DC-DC (MAX8734A)

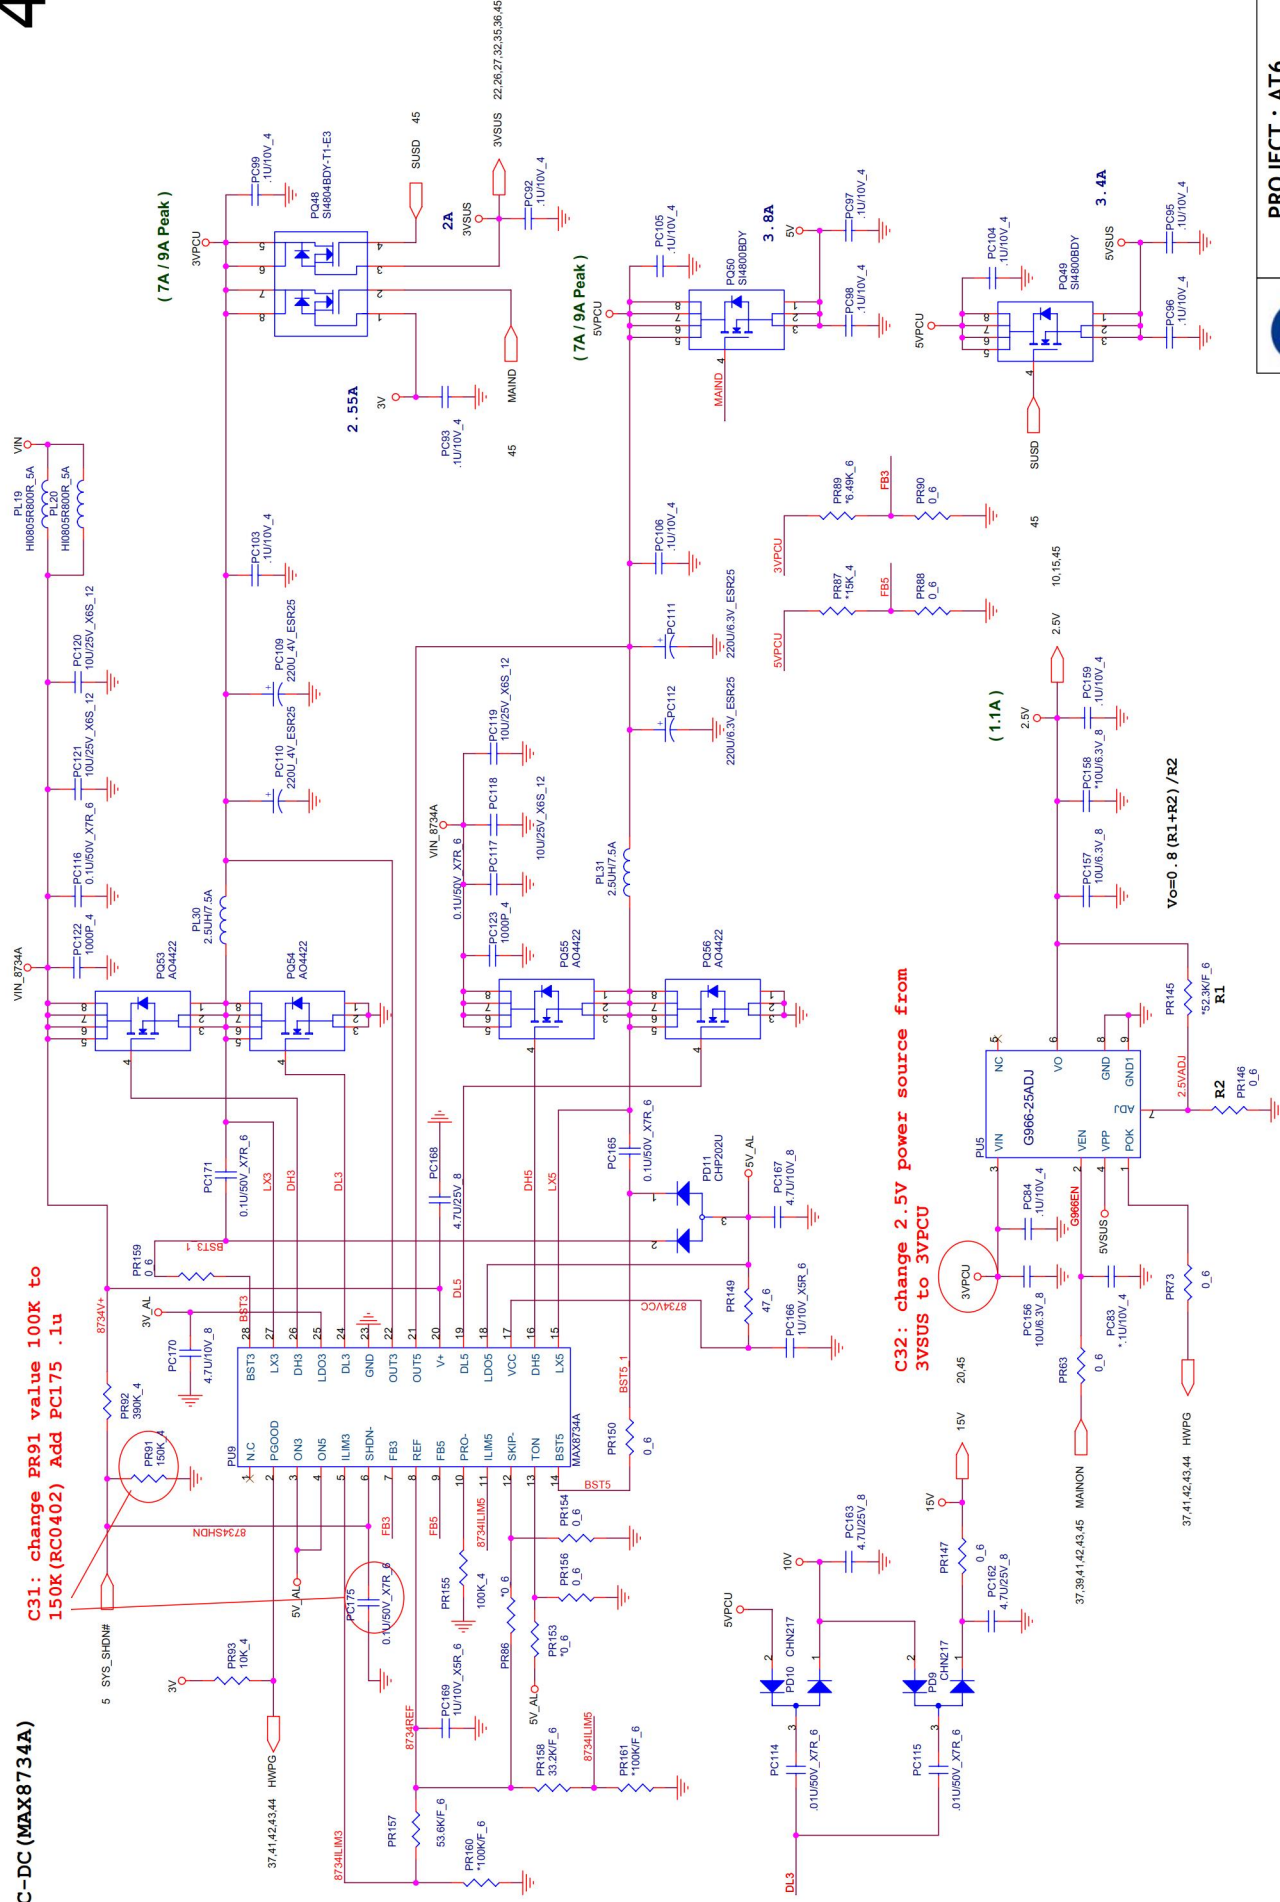
C31: change PR91 value 100K to 150K(RC0402) Add PC175 .1u

C32: change 2.5V power source from 3VSUS to 3VPCU
